**TOWN OF BAY HARBOR ISLANDS
MORRIS N. BROAD COMMUNITY CENTER
1175 95TH STREET
BAY HARBOR ISLANDS, FL 33154**

DEVELOPMENT & REVIEW COMMITTEE MEETING

Subject: Site Development Plan Application (2nd DRC Review)
1085 Townhouses – 6 DU Townhouse Complex
1085 94th Street
Bay Harbor Islands Acct. No. SPR24-000025
MMPA Account No. 01-0702-1197

MMPA recommends the Development Review Committee (DRC) **DEFER** action on the proposed Site Development Plan application at this time to allow the applicant's design team to address the listed comments. The submittal package has several design / Code violation issues, some of the plans are inadequate or missing and a few other items need to be corrected.

SOUTH ELEVATION (94th STREET)

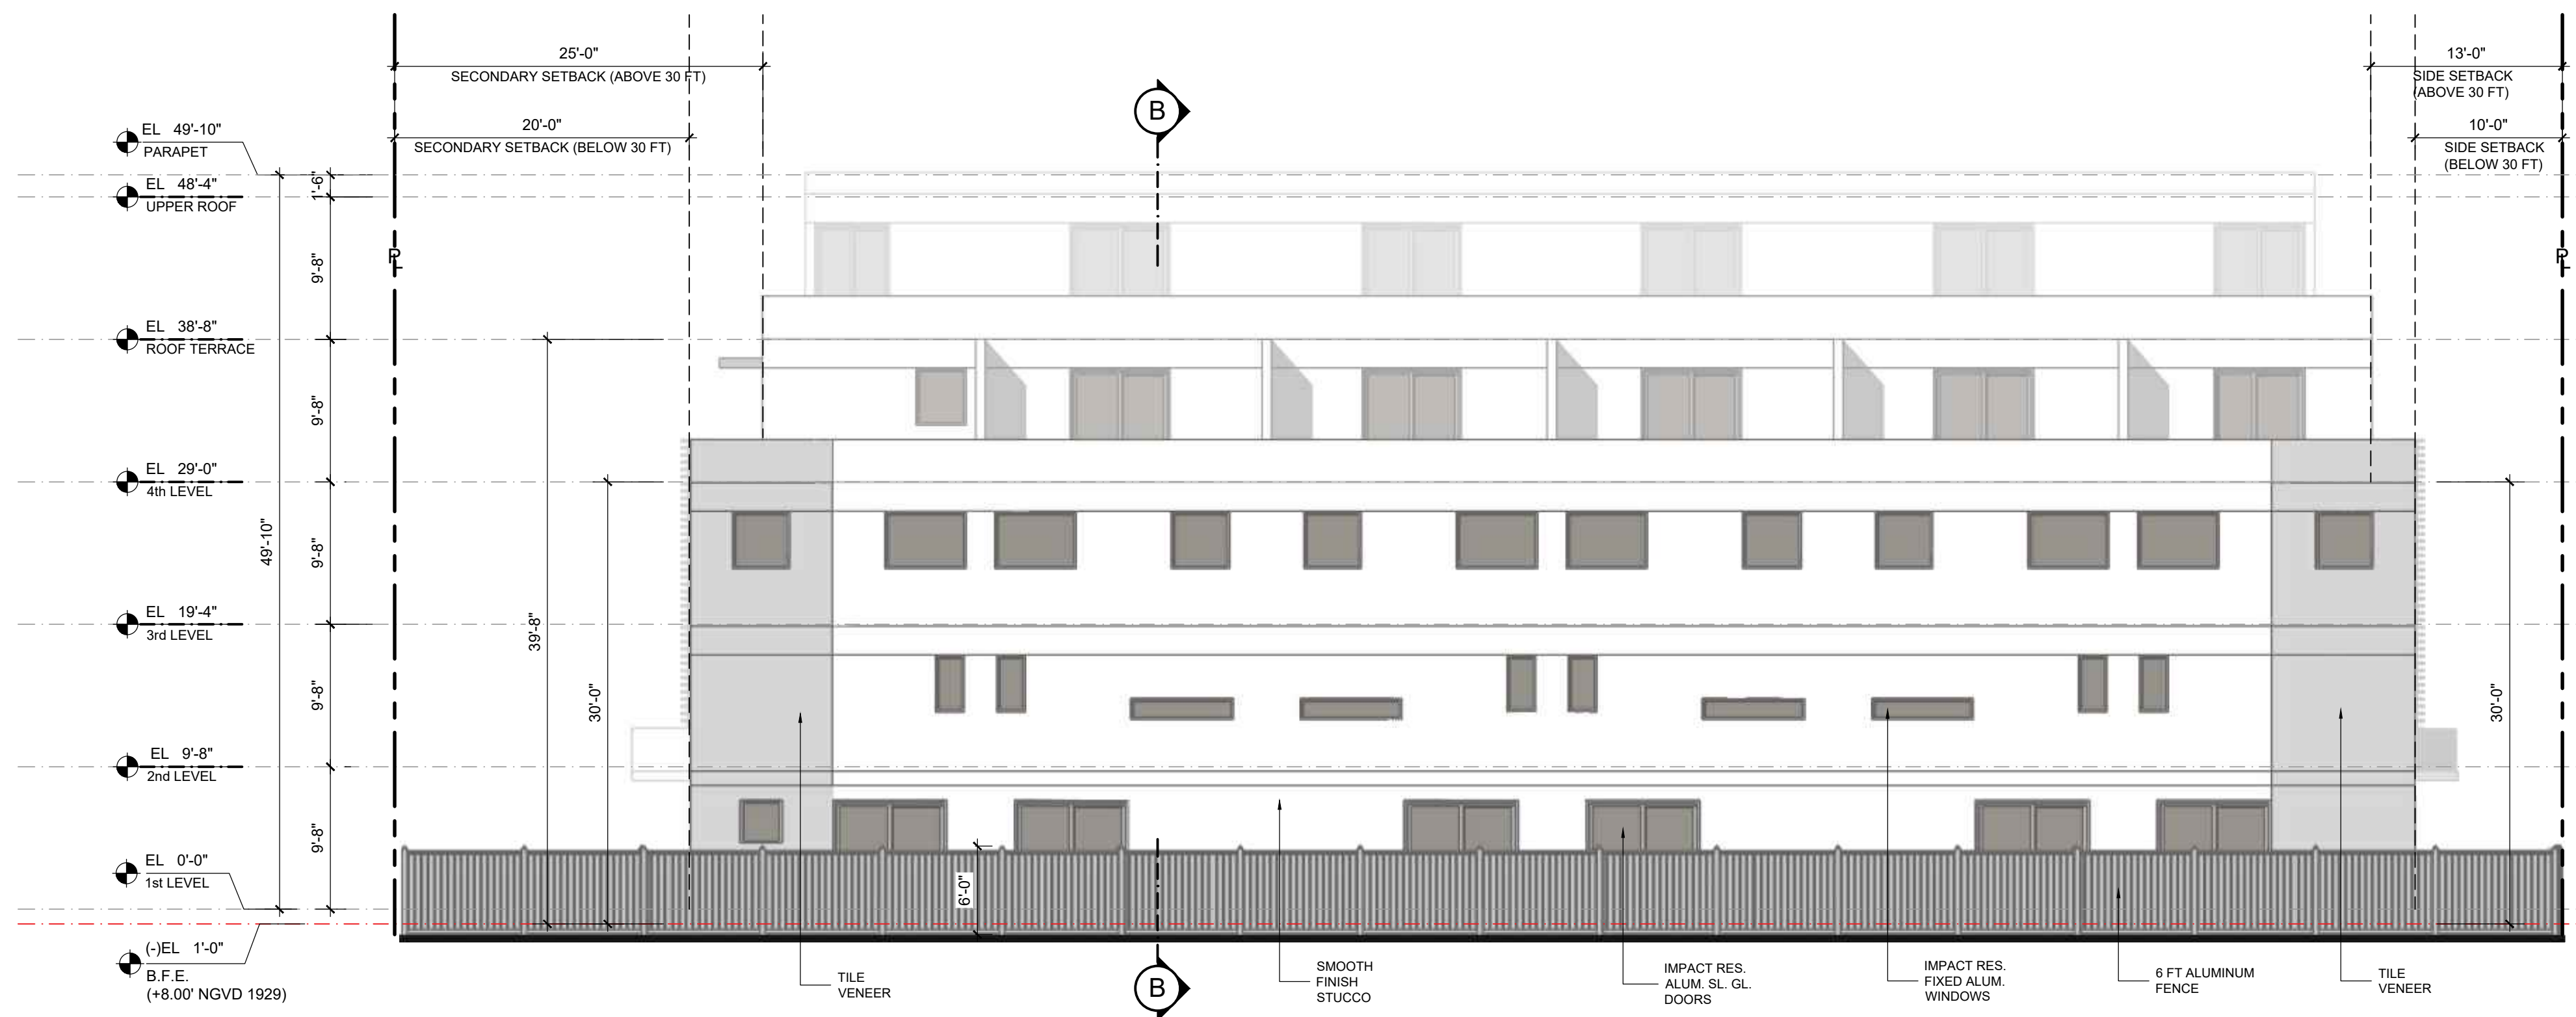
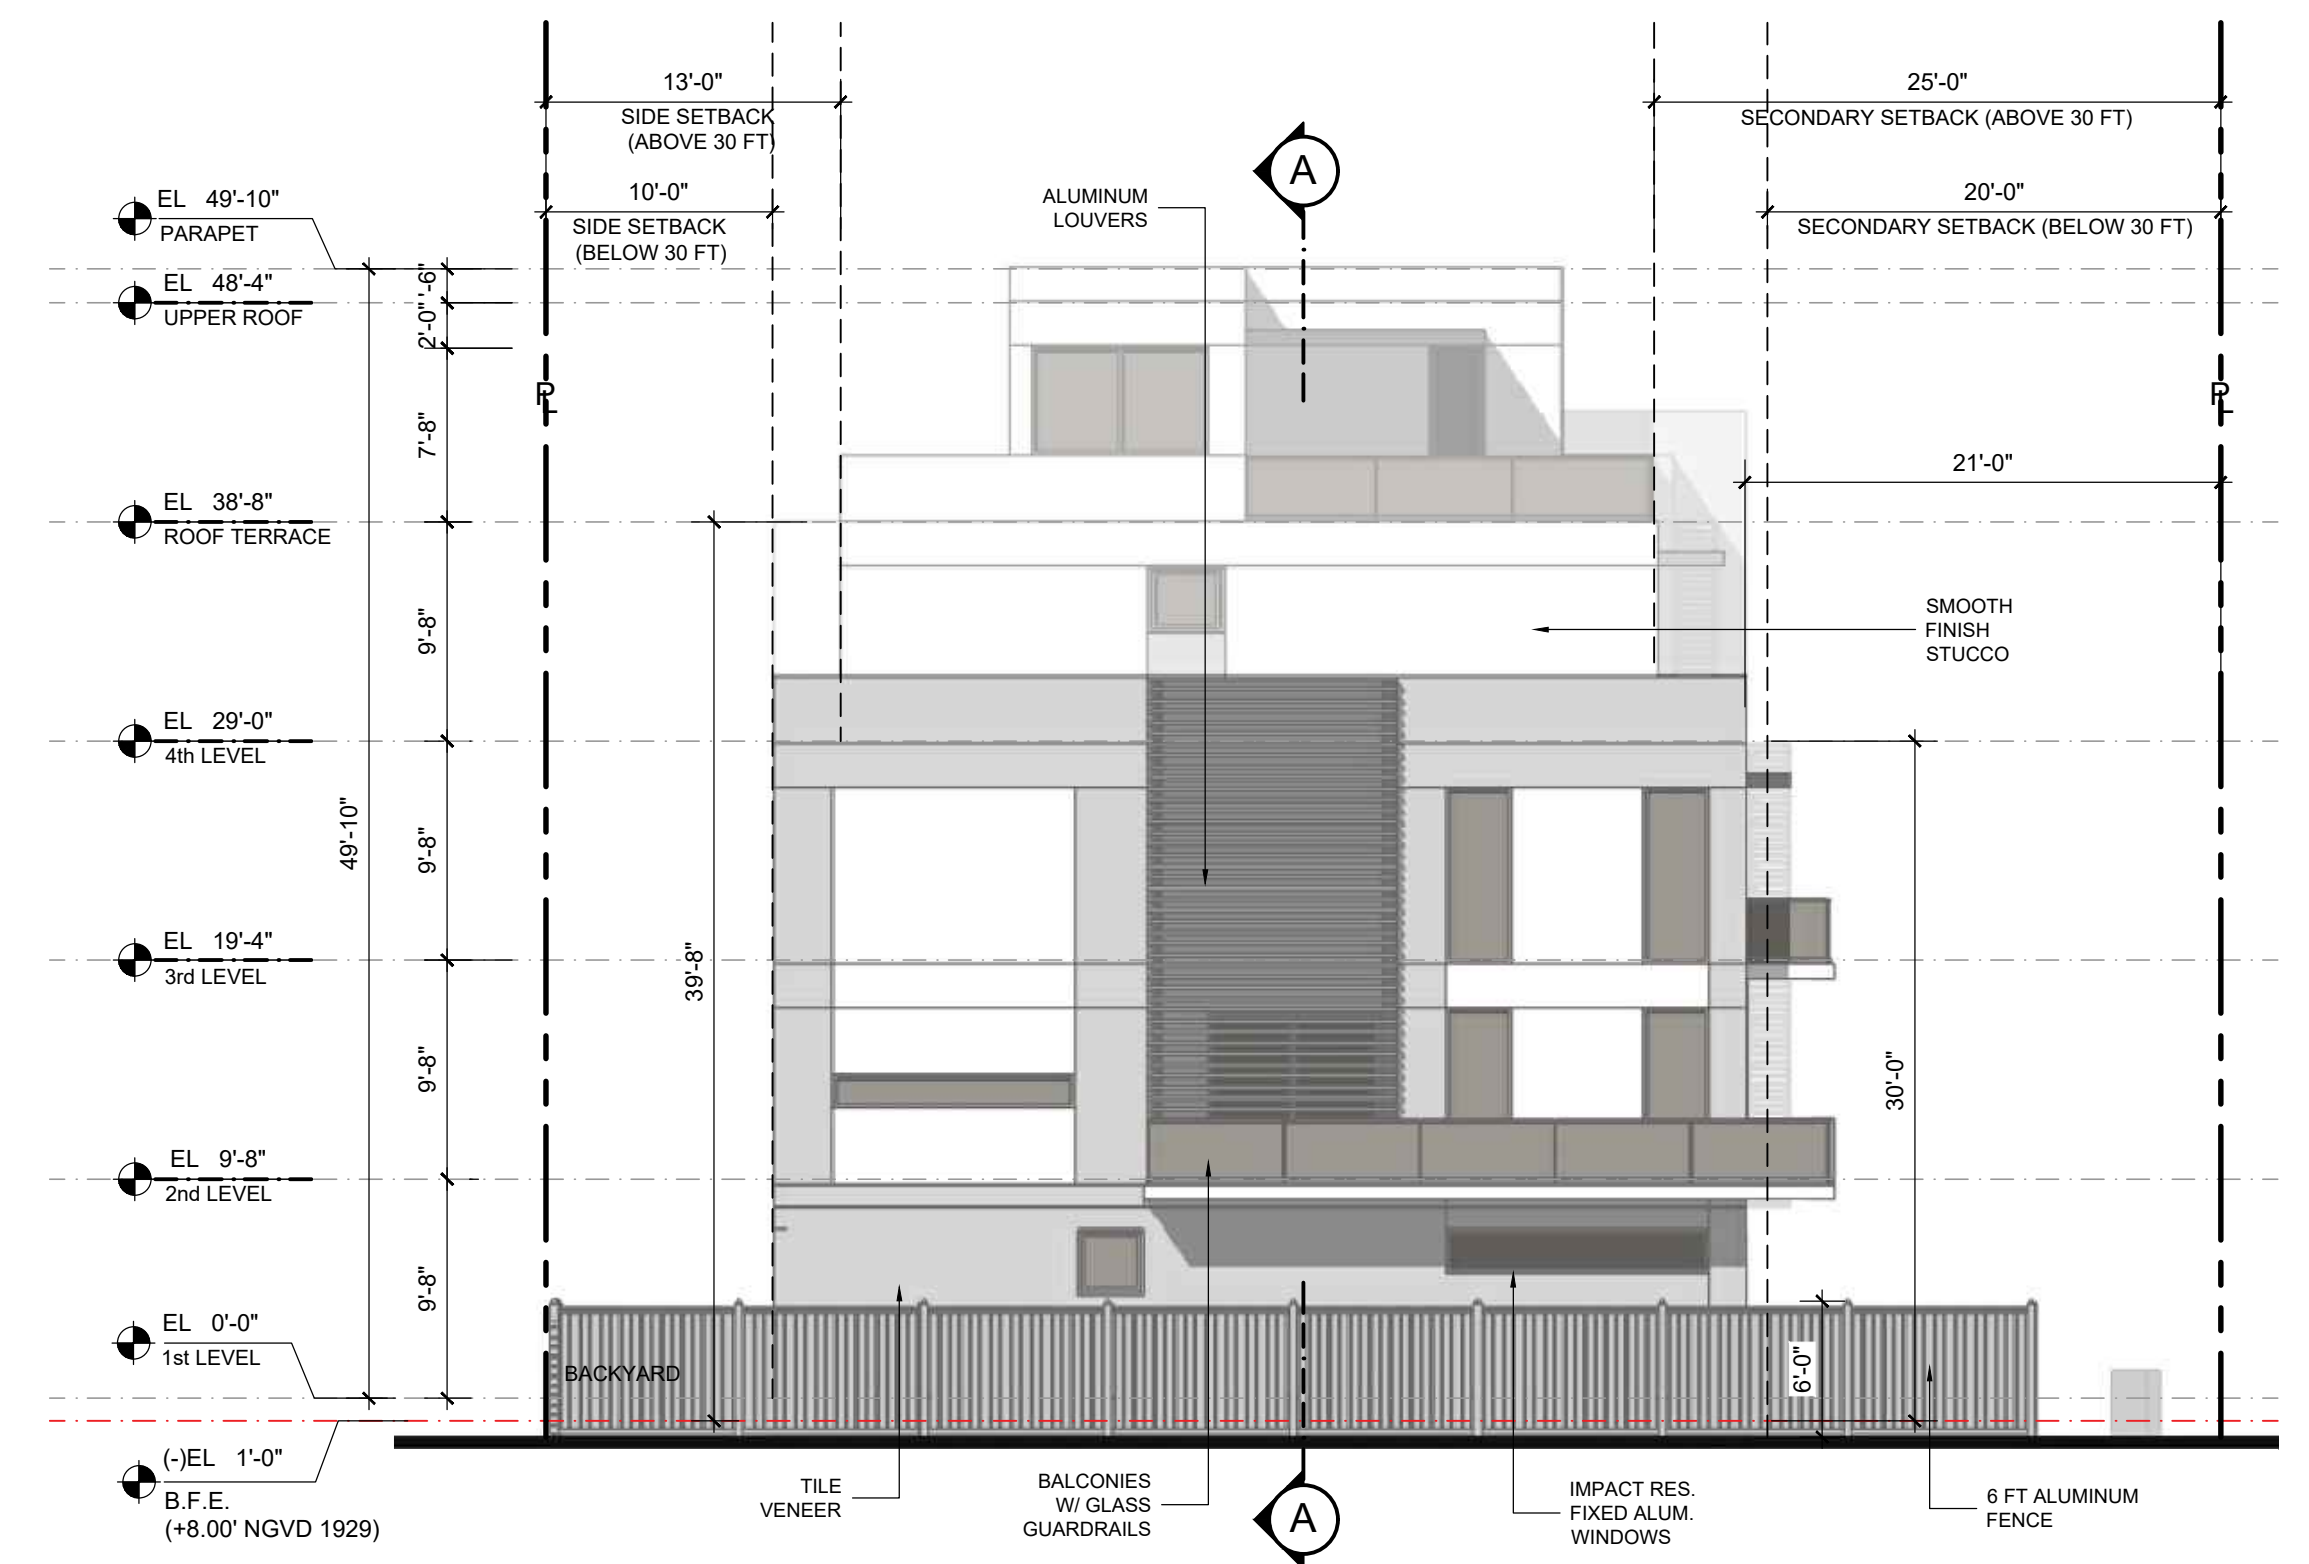
- Elevation Sheet A-3 / others does not scale to 1/8" = 1'-0". Please check and revise.

Revised as requested. Elevation scale is 1/8" = 1'-0"
